RE: ENGINEER'S CERTIFICATION FOR A-1 SELF STORAGE (M-16/D32)
RECEIVED APRIL 25, 1995 FOR CERTIFICATE OF OCCUPANCY
ENGINEER'S STAMP DATED 4-19-95

PROJECT TITLE: A-1 Self Storage ZONE ATLAS/DRNG. FILE #: M16/D32

RE: GRADING & DRAINAGE PLAN FOR A-1 STORAGE (M-16/D32)
RECEIVED MARCH 24, 1994 FOR BUILDING PERMIT APPROVAL
ENGINEER'S STAMP DATED 3/24/94

RE: GRADING & DRAINAGE PLAN FOR A-1 STORAGE (M-16/D32)
RECEIVED MARCH 1, 1994 FOR BUILDING PERMIT APPROVAL
ENGINEER'S STAMP DATED 2/14/94

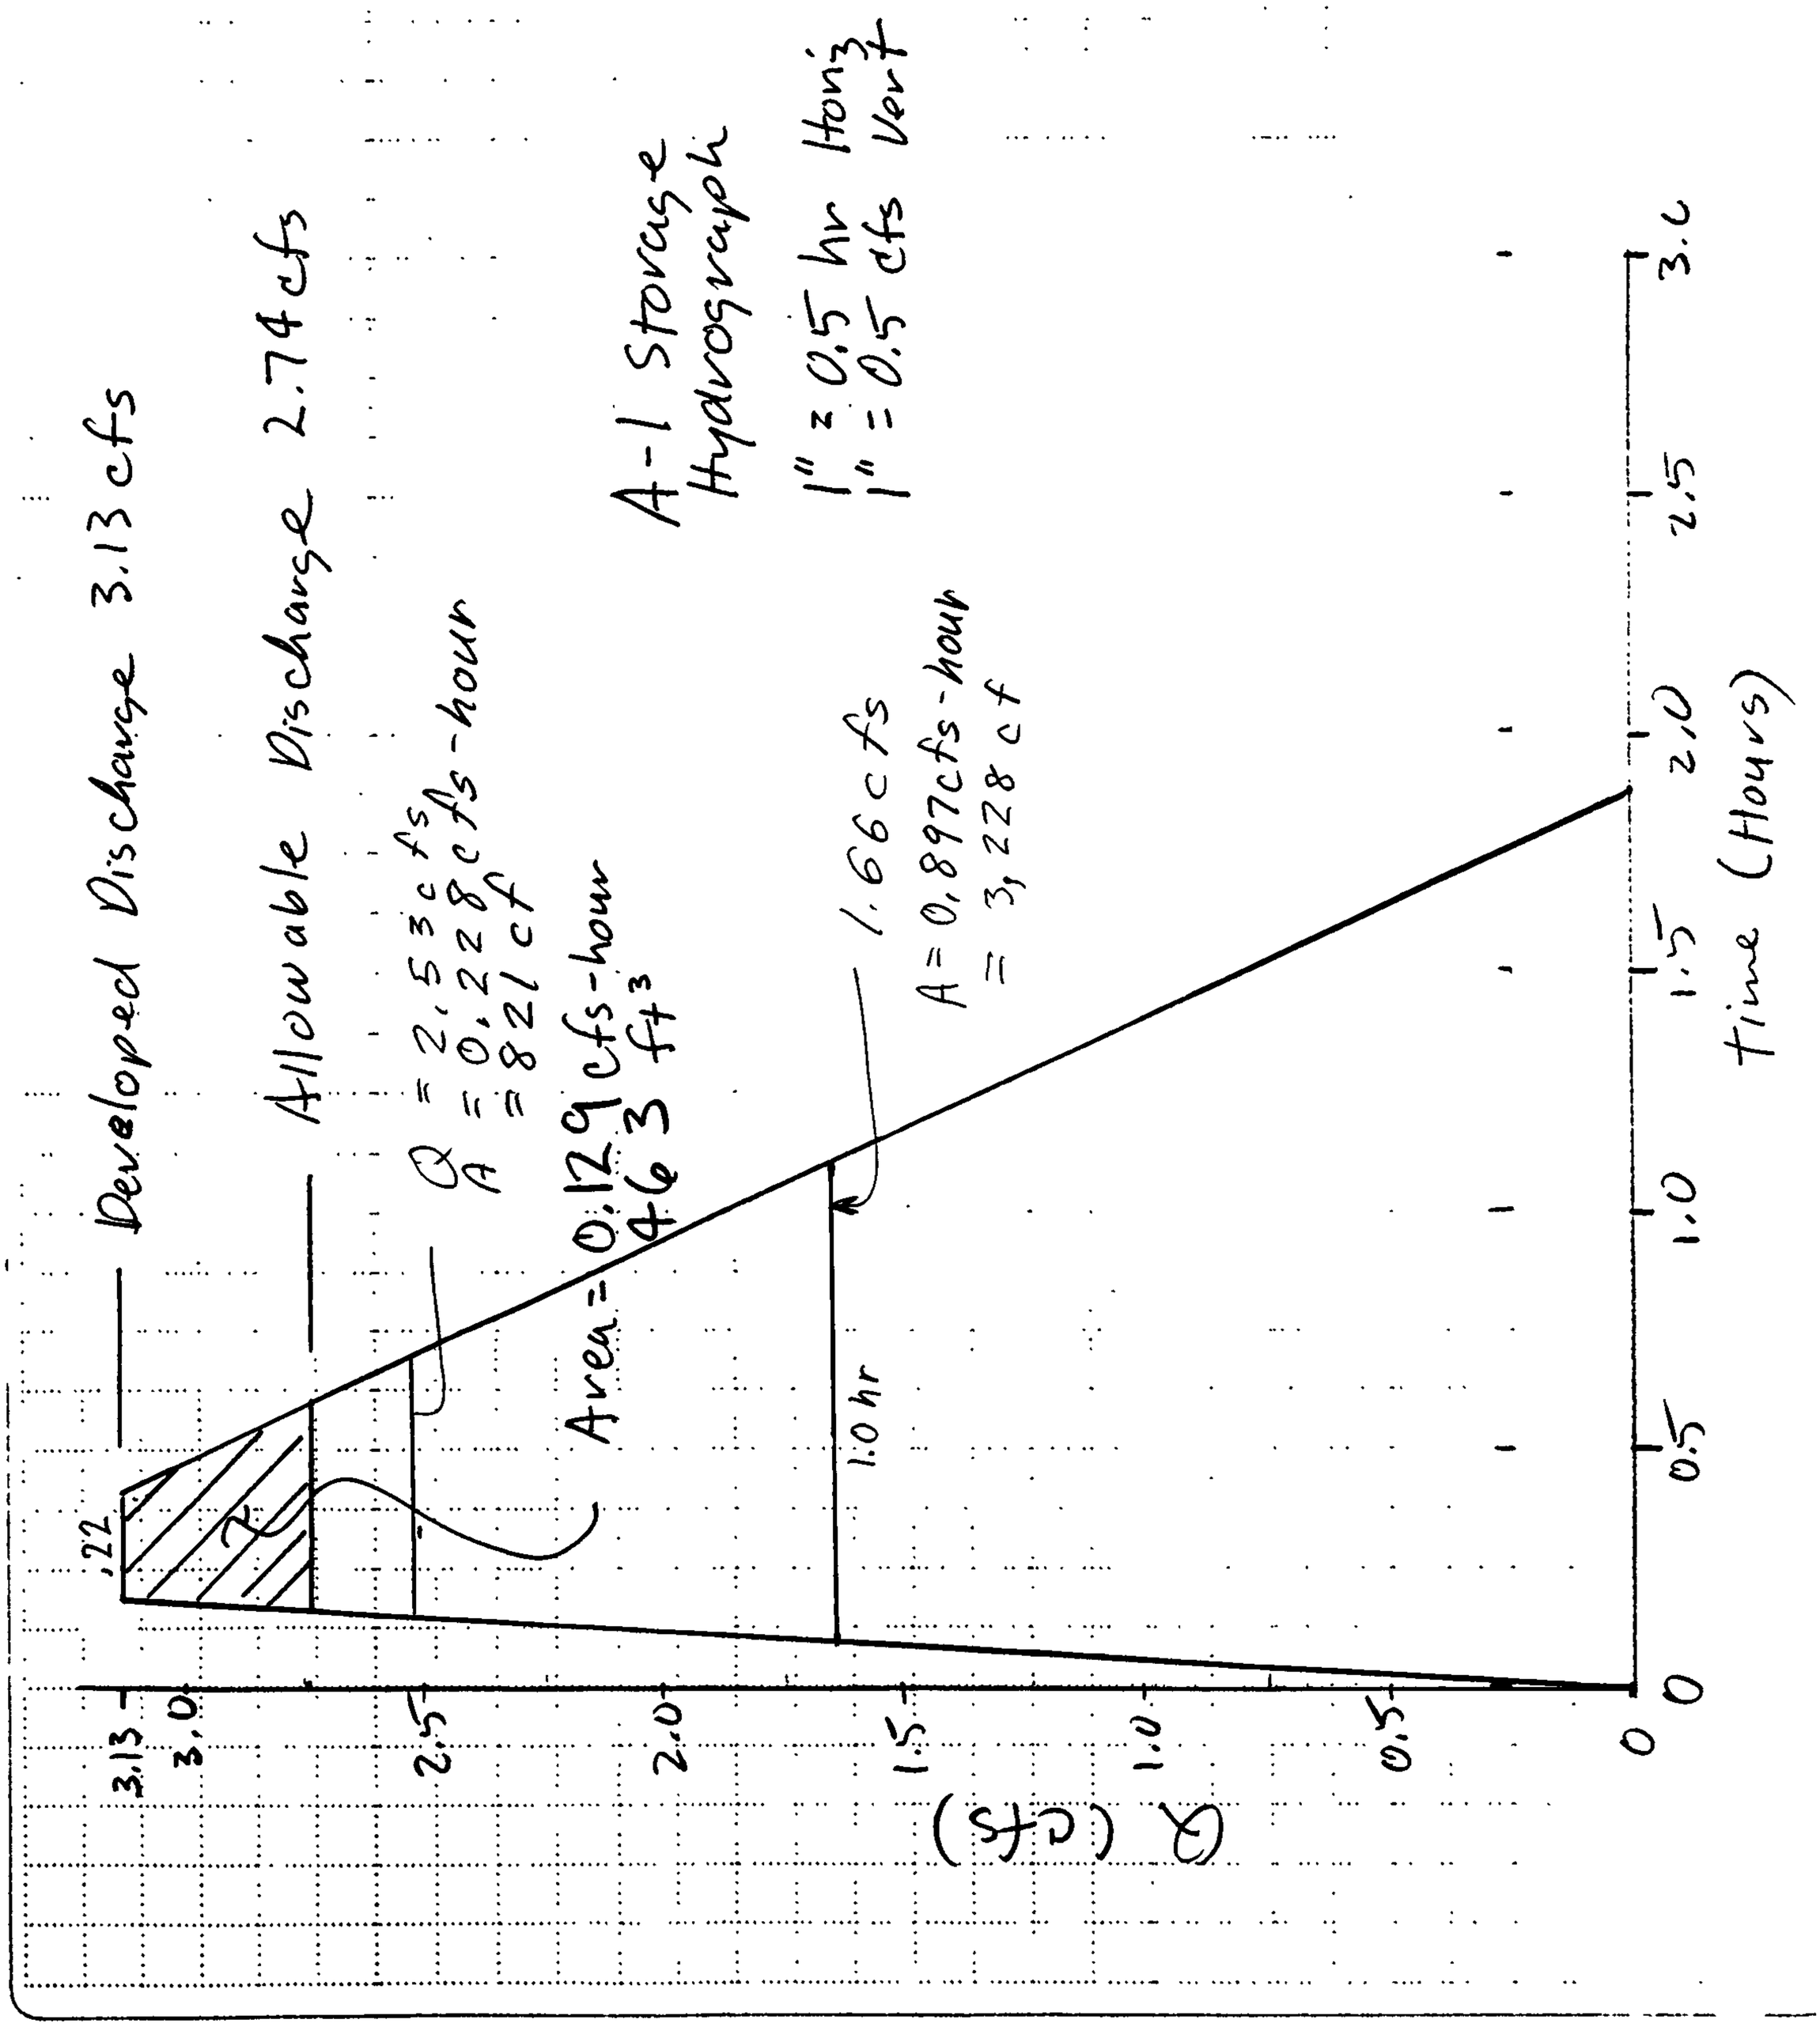
2. Provide hydrograph for pond to determine storage requirements (see attached sketch). Provide calculations determining the storage volume provided. A Private Facility Drainage Covenant must be executed & recorded for the detention pond.

2. The hydrograph for the pond is now included in the drainage calculation package (attached). The pond volume is more than adequate for the developed conditions. The Private Facility Drainage Covenant has been signed by the owner and the original is included in this submittal.

GRADING & DRAINAGE
LOT 15 BLOCK 2
AIRPORT INDUSTRIAL PARK
ALBUQUERQUE N.M.

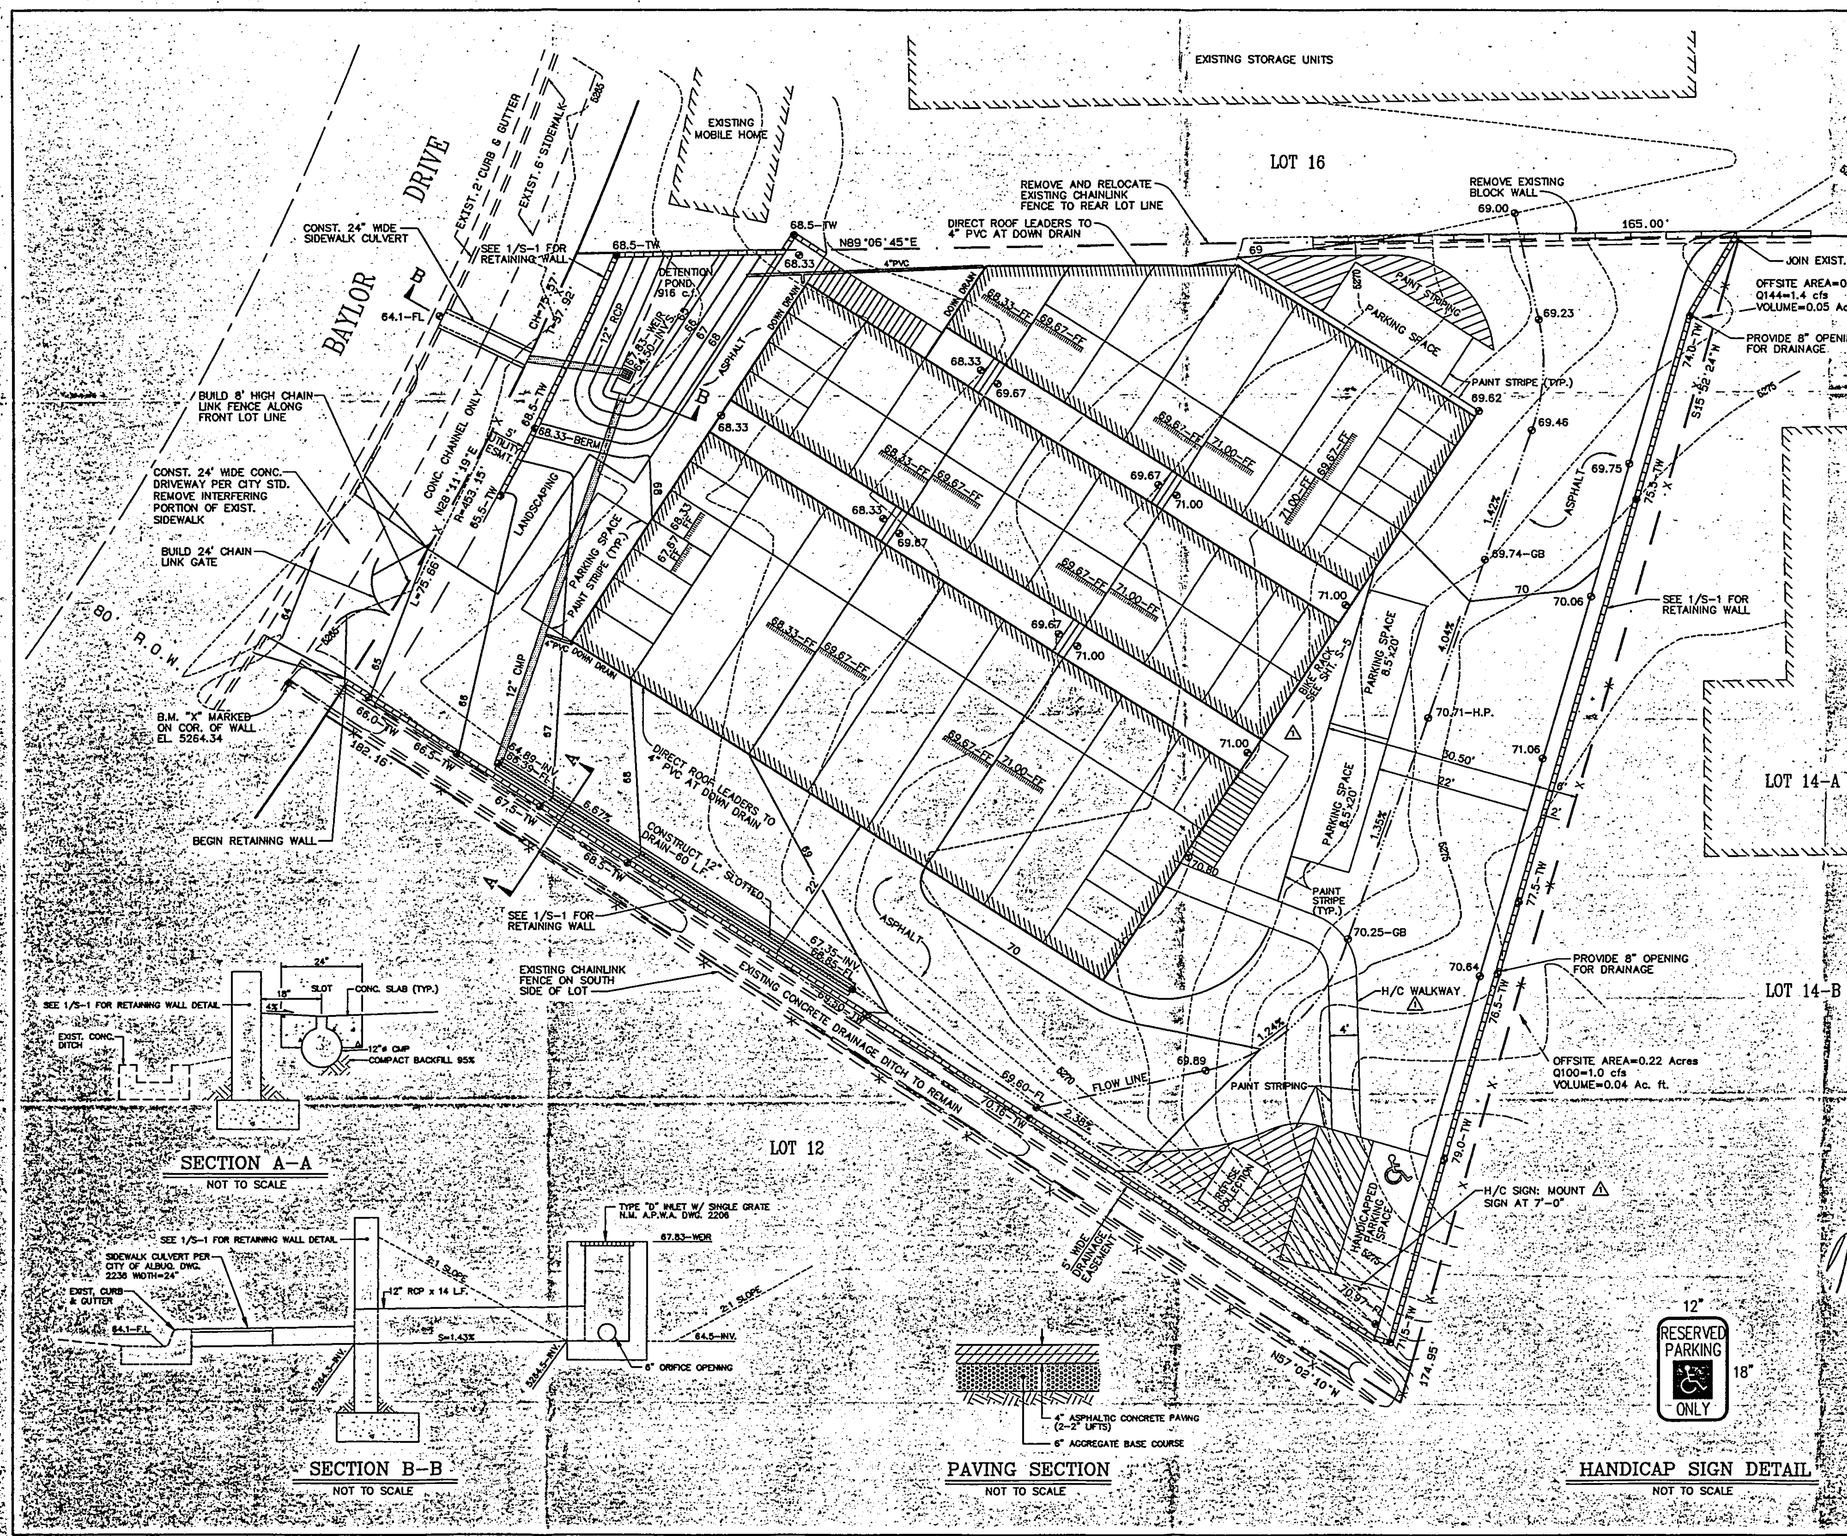
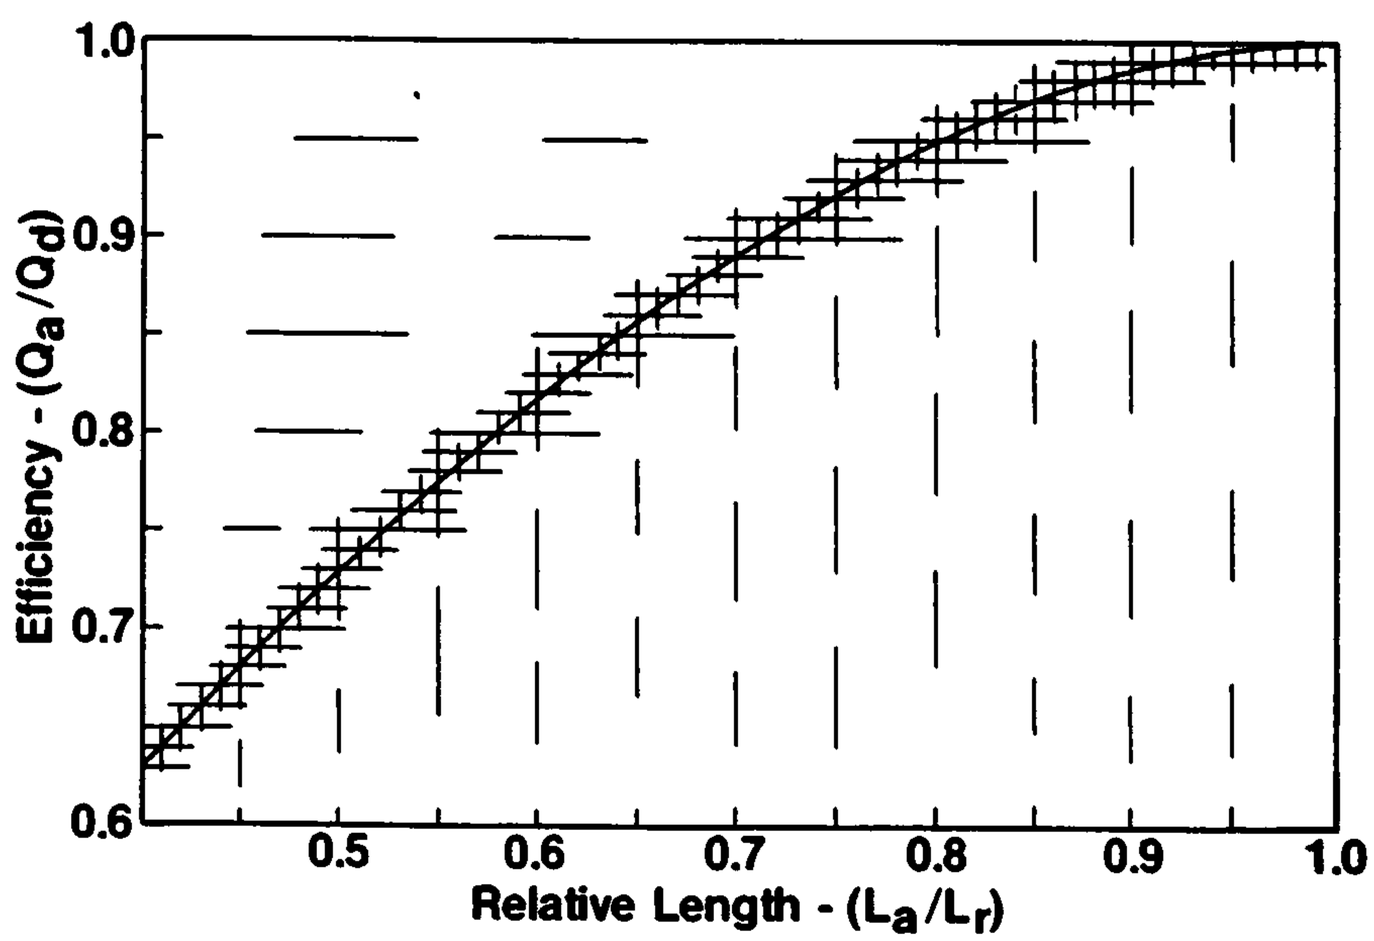
1. Identify the off-site drainage basin to the east. Calculate the flow rate and volume entering the site. Show the boundary of the basin on the Grading & Drainage Plan (on the vicinity plan would work).

3. The emergency spillway must be designed to carry Q100. Provide orifice calculations for the 12" emergency spillway and the 6" orifice. Remember, H is measured from the water surface to the CENTER of the opening not the BOTTOM.

4. Section B-B must have sufficient inverts to install the outlet system. The sidewalk culvert requires the S.O. 19 process for Private Storm Drain Improvements Within City Rights of Way. Sidewalk culvert must be installed per City of Albuquerque Dwg. 2236.

5. Section A-A does not provide sufficient detail to construct Slotted Drain. When the slot is cut in the 12" CMP the structural integrity will be effected. City Hydrology recommends that the Slotted Drain be constructed similar to City of Albuquerque Dwg. 2225.

6. Grading & Drainage Plan must include Erosion Control Notes. Notes must address how sediment will be contained on site; what the Contractors responsibilities are if sediment enters adjacent property. The Contractor must obtain a "Topsoil Disturbance Permit" from the Environmental Health Department prior to any grading or construction.

7. The runoff calculation's sticky-back is hard to read. All letters must be atleast 0.10" tall per DPM standards. Is there a gap in the retaining wall at the SE corner? A bolder line would help the retaining walls stand out from the other lines. Show how roof drainage is routed to the pond.

1. The offsite drainage area has been shown on the vicinity map. The peak discharges and volumes of runoff are shown on the grading and drainage plan. Since the final as-built conditions of the offsite area is not shown on the city topography, each flow rate and volume was estimated by using the design data for this site. Since the A-1 site is a fully developed, this would be conservative.

3. The emergency spillway capacity is more than adequate to convey the 100 year discharge. In the attached calculation package, the analysis assumed the 6" orifice was clogged and the flow was from the top of the "D" inlet. The velocity is greater than the minimum of 3 fps.

4. Additional invert elevations are shown on Section B-B to indicated adequate flow velocity. The owner will obtain all required permits and maintain the facility in accordance with S.O. 19. The sidewalk culvert will be installed per Dwg. 2236.

5. Per our telephone conversation, the slotted drain pipe is manufactured (specifications attached) and the detail is adequate for this type of pipe.

6. The Erosion Control Notes are shown on the plans. The contractor will obtain the necessary "Topsoil Disturbance Permit".

7. The runoff calculations have been removed from the drawings and are included in the attached package. The roof drainage is shown being routed to the pond.
